State of Utah
 DEPARTMENT OF NATURAL RESOURCES
 DIVISION OF OIL, GAS AND MINING

October 30, 1997

RE: UC-3 Culvert Extension, Horizon Coal Corporation, Horizon Mine, ACT/007/020-97D, Folder #2, Carbon County, Utah

Horizon Coal Corporation has submitted an amendment for extending Culvert UC-3 100 feet northward. The 36 inch, UC-3 culvert currently carries Jewkes Creek beneath the lower pad area and around the sedimentation pond. The purpose for the culvert extension is to alter the truck turnaround radius, thus enlarging the lower facilities pad for safety reasons.

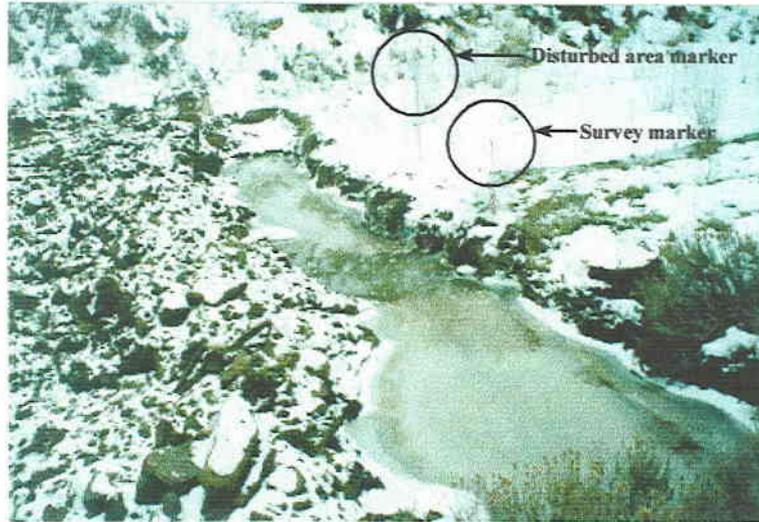
The disputed area for the culvert extension lies northward of the current disturbed area boundary as shown in the approved MRP and on photographs (see Figure 1 of this TA memo) taken during construction last fall, 1996. The placement of the disturbed boundary marker as shown in Figure 1 is consistent with the marked disturbance boundary as shown in the original approved Mine Reclamation Plan. However, Horizon claims this area as part of the established disturbance area because of errors in surveying that were corrected during a survey performed during the summer of 1997. Drawing A, Appendix 3-9, shows the revised disturbance boundary as it exists in the field after the 1997 survey.

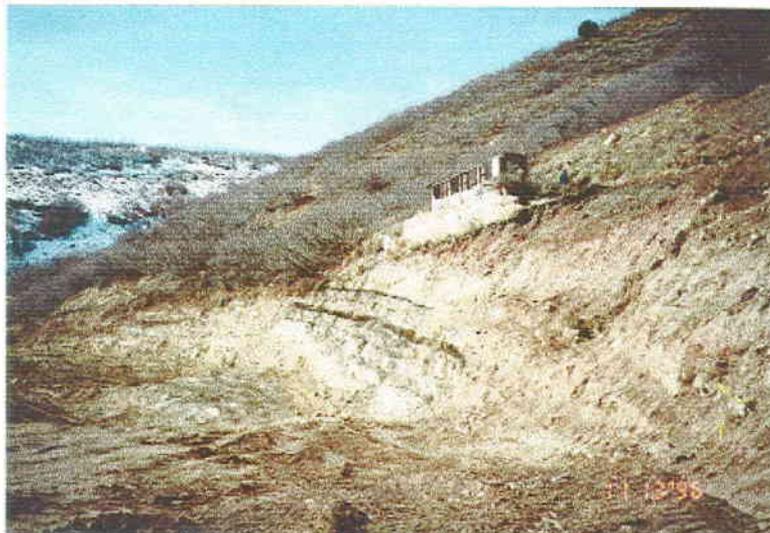
- *Photographs from last fall (Figure 2 of this TA) show that all north, northwest hills located adjacent, immediately above the Portal Canyon pad and below the soil stockpile were disturbed during the 1996 fall construction period. Figure 8-2 clearly shows that no soil was salvaged from these slopes, yet the photograph (TA Figure 2) clearly shows that these hillsides were affected during construction. Therefore, if these slopes were affected during construction, why wasn't soil salvaged?*

- *Since the amendment states that the hill will remain undisturbed, how can this statement be rectified since these north, northwest hills were disturbed?*
